April 13, 2015

**Subject: Century Tire Plaza – 195 Kennebec Street
Project ID# 2015-027
Review Comments Received April 8, 2015**

PRELIMINARY - NOT FOR CONSTRUCTION

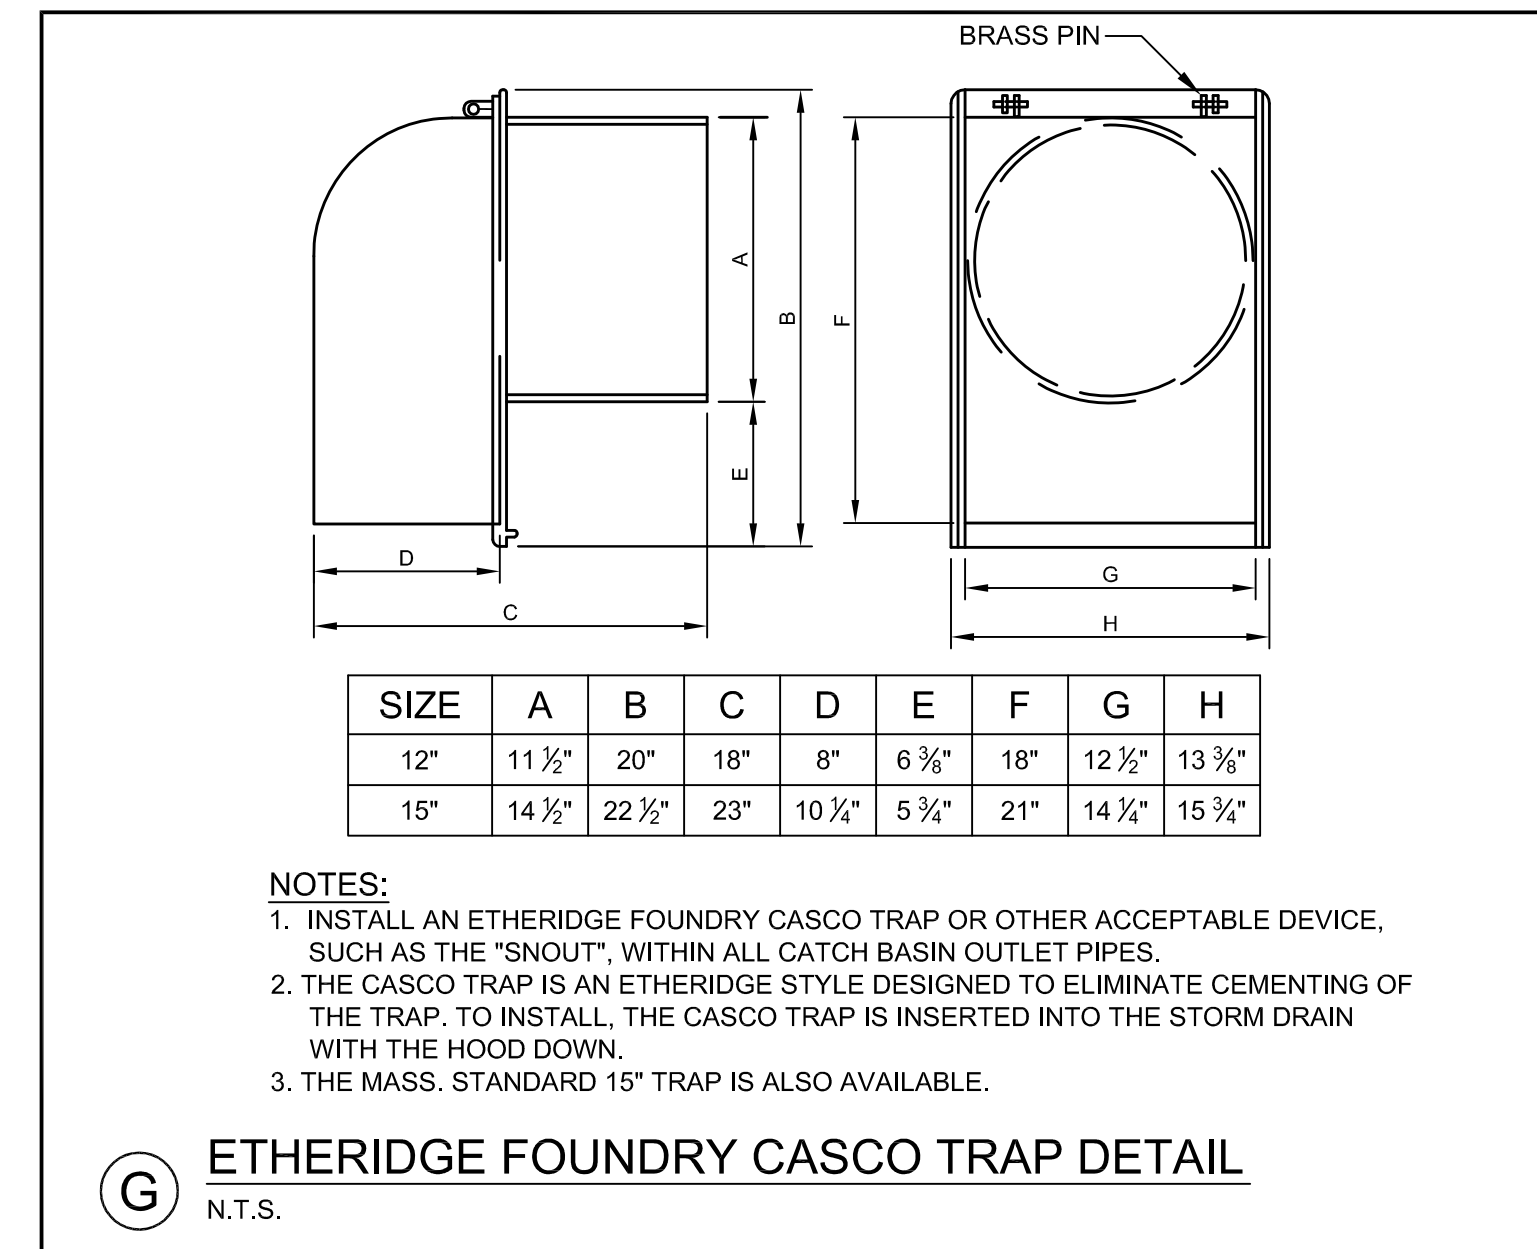
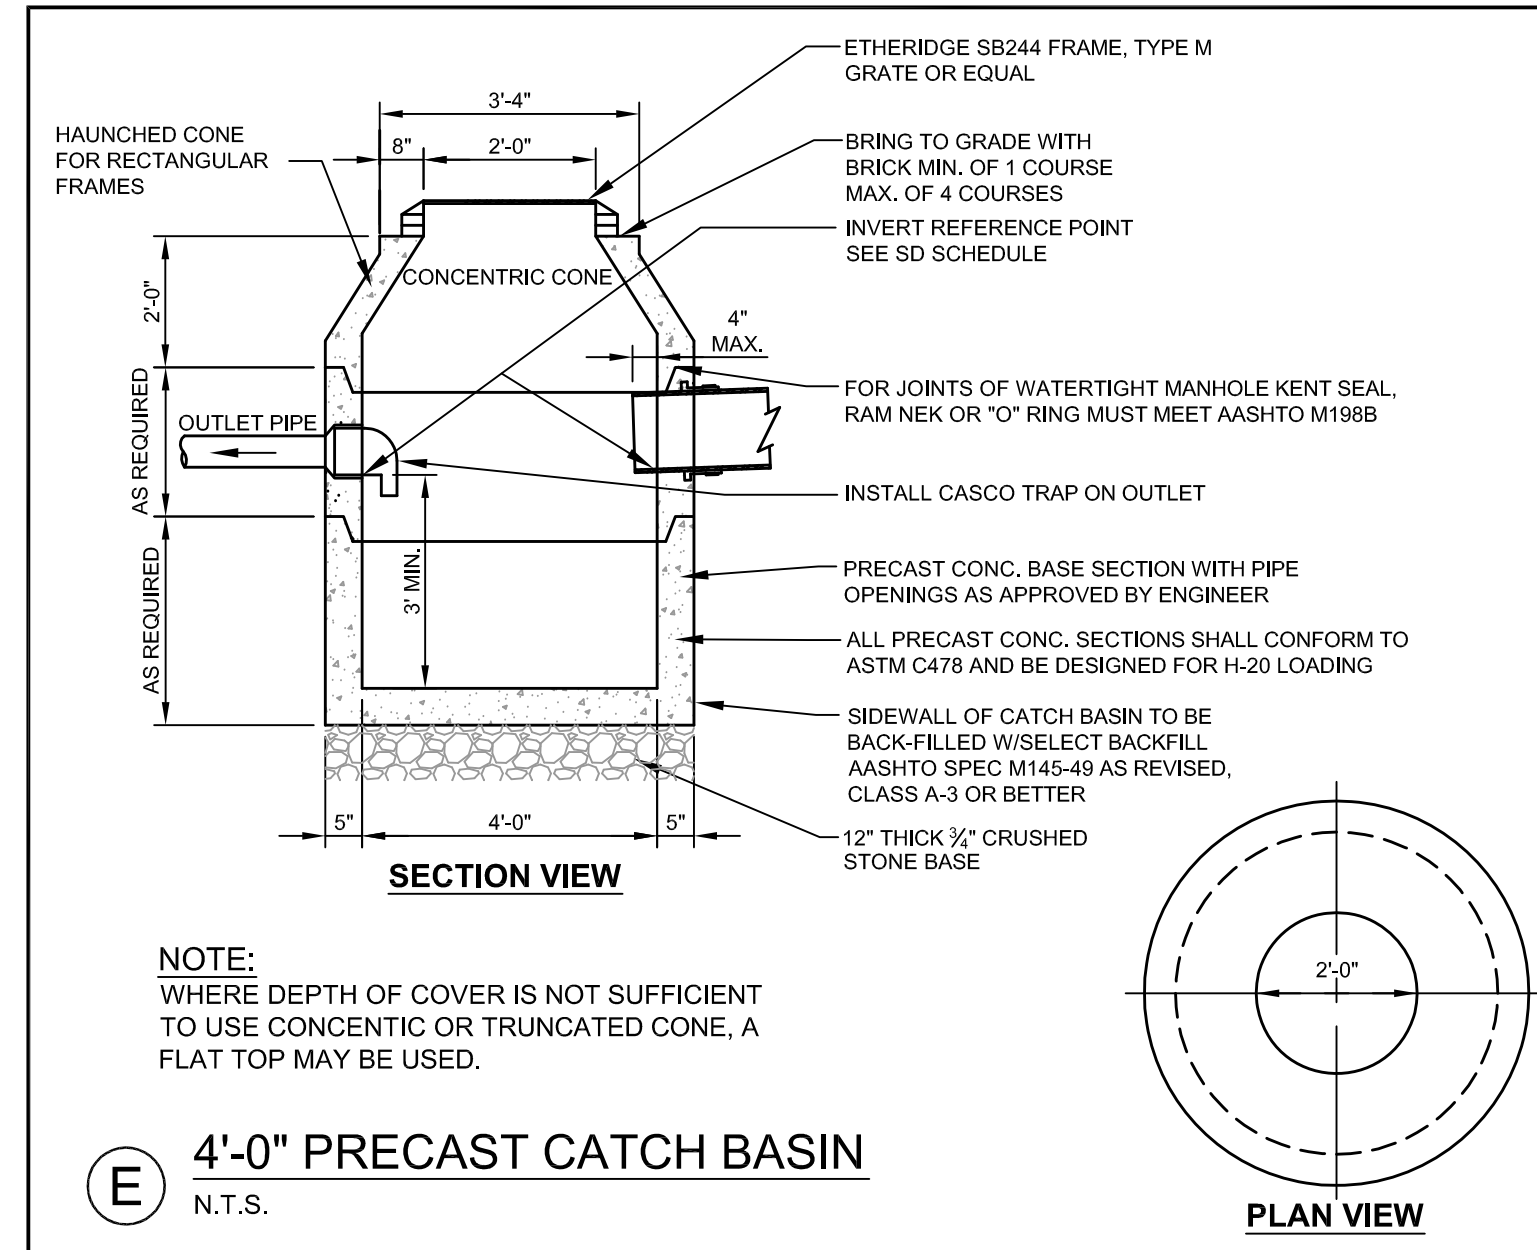
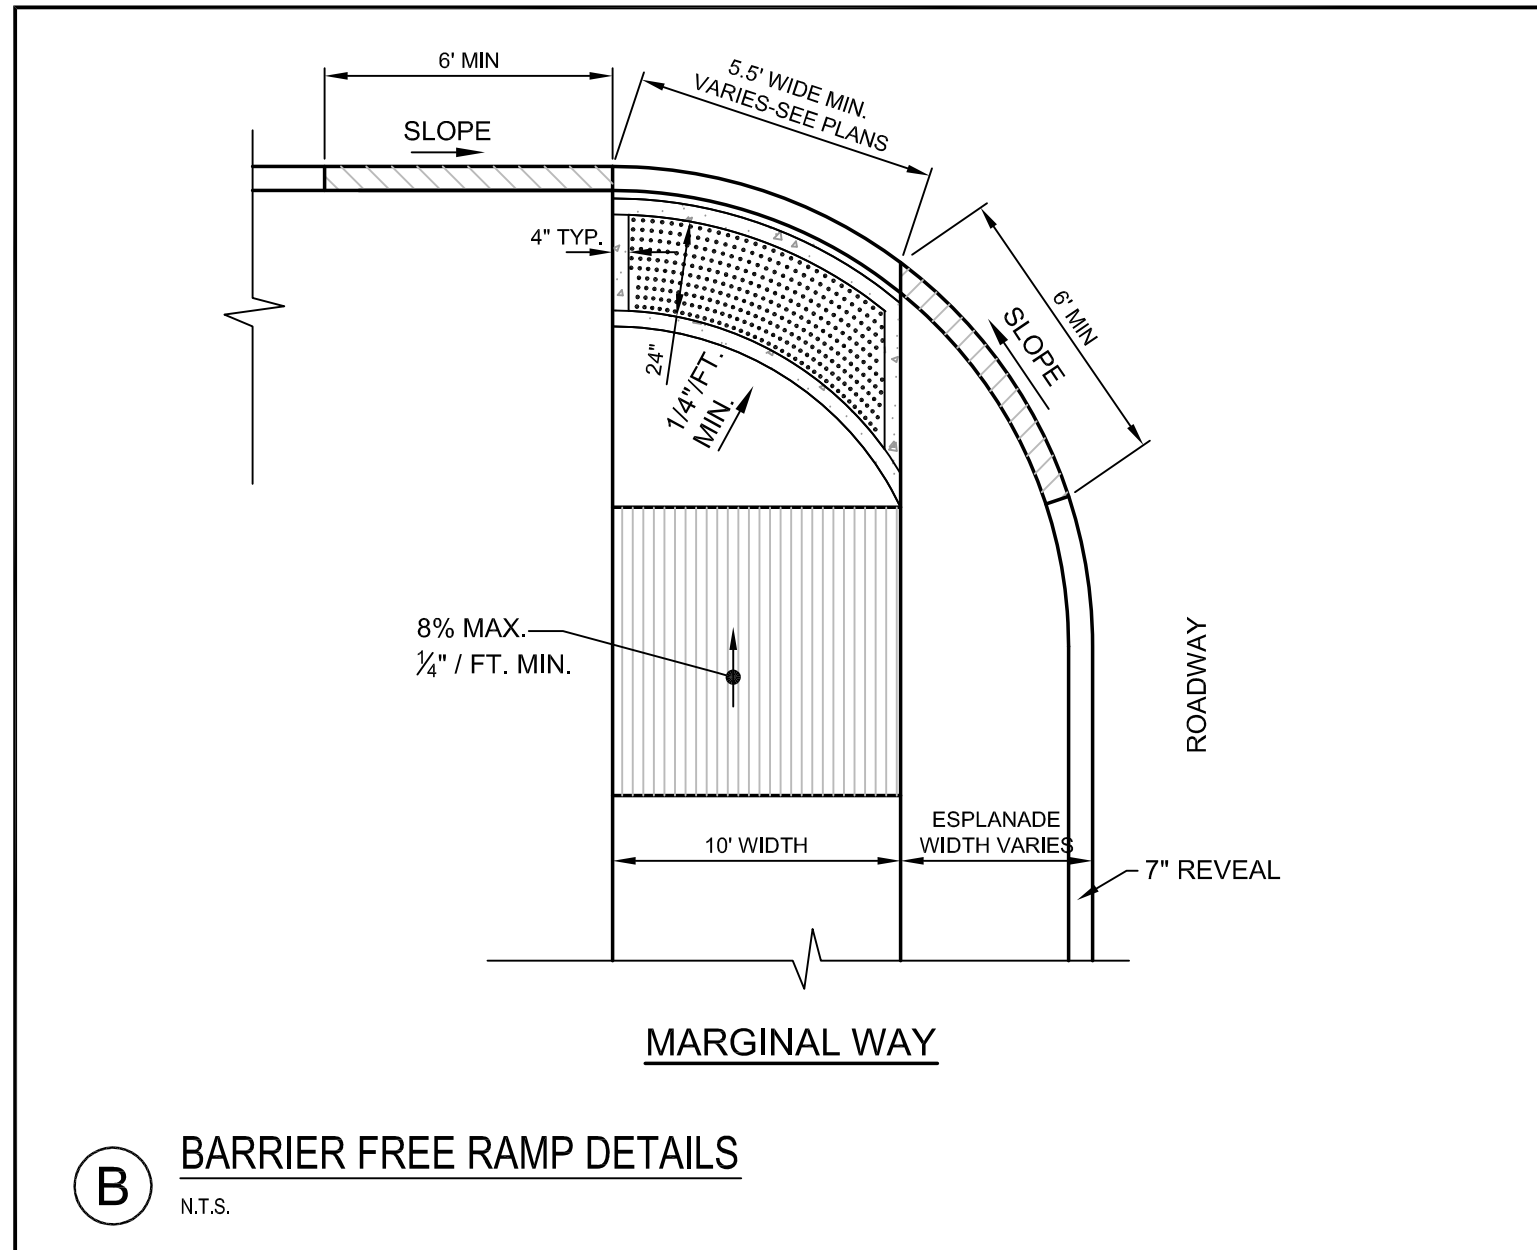
Detail A on plan sheet C-7.1 shows a curb reveal of 6 inches along Kennebec Street. The City standard for curb reveal is typically 7 inches. The curb reveal should be changed to match the City standard unless there are over-riding considerations that require a 6 inch curb reveal. A change to 6 inch curb reveal may require changing the specification for granite curb terminal pieces from 6 feet to 7 feet in length.

The curb reveal dimensions have been amended on the revised plan sheets.
